We write on behalf of California Unions for Reliable Energy ("CURE") to provide comments on the Initial Study/Mitigated Negative Declaration ("IS/MND")¹ prepared by Riverside County ("County") for the Painted Hills Wind Repowering Project ("Project"), proposed by Painted Hills, LLC, which is owned by Terra-Gen ("Applicant").

The Project proposes to decommission and remove approximately 291 existing commercial wind turbines and install up to 14 new commercial wind turbines up to 499-feet in height with a per turbine generating capacity of between 2.0 megawatts ("MW") and 4.2 MW, which is up to 58.8 total MW, on land within the Wind Energy Resource Zone. The Project will also install ancillary equipment, including meteorological towers up to 309-feet in height, new access roads, collector circuits, and substation.

To: Jay T. Olivas, Riverside County Planning Department
From: Adam Poll, Dudek; and Michael Greene, Dudek
Subject: Painted Hills Wind Energy Repowering Project – Response to Comments
Date: November 27, 2018
cc: Collin Ramsey, Dudek
Attachment: None

SUBJECT: TRANSPORTATION & LAND MANAGEMENT AGENCY/PLANNING: RECEIVE AND FILE THE PLANNING COMMISSION'S APPROVAL OF COMMERCIAL

Photo 1 (USFWS)

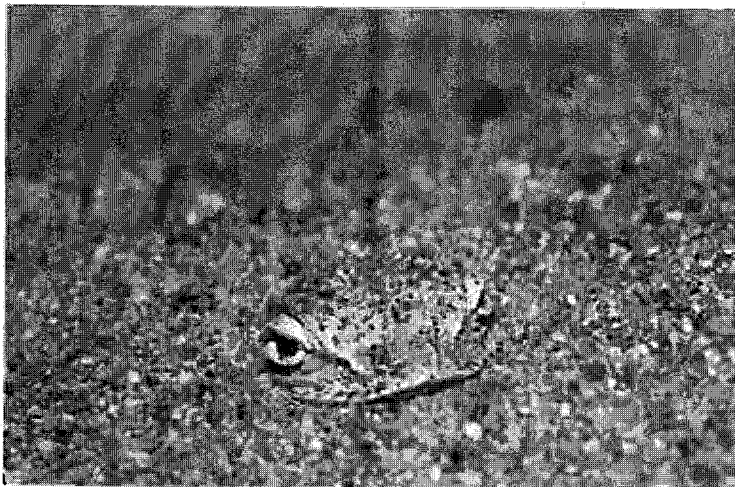
Due to their cryptic nature and difficulty to detect without conducting focused surveys, reptiles are historically underserved in conservation management plans, including those dependent on environmental impact analyses. As co-researcher of the world's most extensive study of the world's largest snake species, the green anaconda (*Eunectes murinus*), I discovered the difficulty of visually locating a secretive species despite the fact it can be over 17 feet long. This species had not been studied to any extent previously due primarily to the false belief that they were not in high abundance anywhere and thus difficult to observe for research. However, once I and my associate conducted focused surveys where they had been anecdotally observed, we caught over 800 anacondas within a few square kilometers, using a focused technique that involved tactile searching among other methods, not visual observations⁴⁶. Visual searching alone resulted in missing over 90% of the individuals encountered via an alternative focused methodology.⁴⁷ This example keenly underscores how even one of the largest reptile species in the world can be very difficult to detect if one is not conducting surveys with a protocol and methodology designed for species-specific detection. Additionally, desert habitats that reptiles use typically include more than those identified as preferred habitats or optimal foraging habitats, and as a result environmental impact analyses that estimate the "potential to occur" of reptiles species based only such assertions of "preferred habitat" in the literature, and not focused field surveys, typically fall short of accurate site assessments regarding species presence and use.^{48,49,50,51}
